Stanton Dahl Architects

Job Number
230291

Stormwater Issues for proposed development
70-72 Gordon Avenue, South Granville NSW
Ref: OA2022/0010

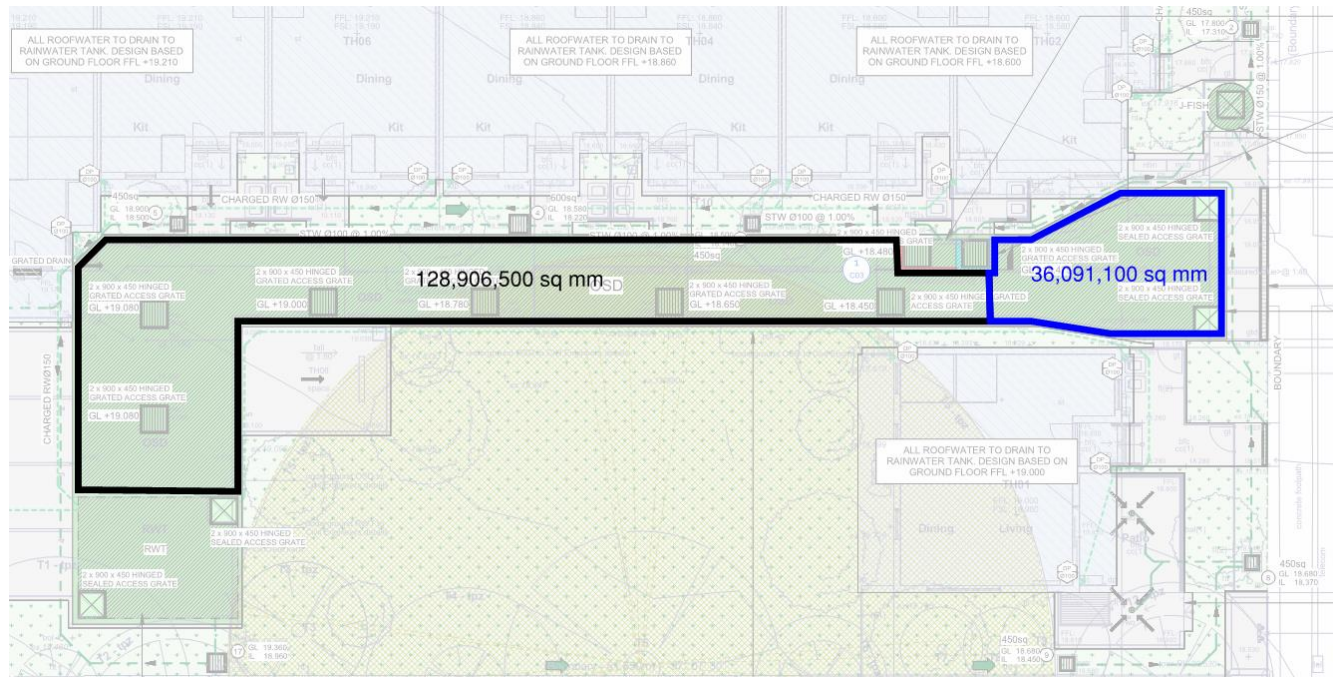
5. The OSD storage volume proposed insufficient and less than the minimum required.

OSD volume has been checked twice and is sufficient even in the submerged case. OSD achieved 90m³ and requires 82.6m³ in the submerged case. Refer detailed volume calcs below.

Black section, 128.9m² plan area, TWL = +18.175mAHD, longest run = 32.5m, invert level at hed chamber = +17.45mAHD, therefore highest base of tank invert level = +17.45 + 1% * 32.5m = +17.775mAHD. Average base RL therefore equals +17.6mAHD. TWL – average base RL = average depth = 0.575m. Therefore, volume achieved in black section = 74.1m³

Blue section, 36m² plan area, TWL = average RL of slab – 200mm for slab = +18.1225mAHD, longest run = 10m, invert level at HED chamber = +17.45mAHD, therefore highest base of tank invert level = +17.45mAHD + 1% * 10m

= 17.55m AHD. Average base RL therefore equals +17.50m AHD. TWL – average base RL = average depth = 0.423m. Therefore volume achieved in blue section = 15.2m³

Total volume = 74.1 + 15.2 = 89.3m³ > 82.6m³ in submerged case. Design allows for 6.7m³ of structural walls internal.
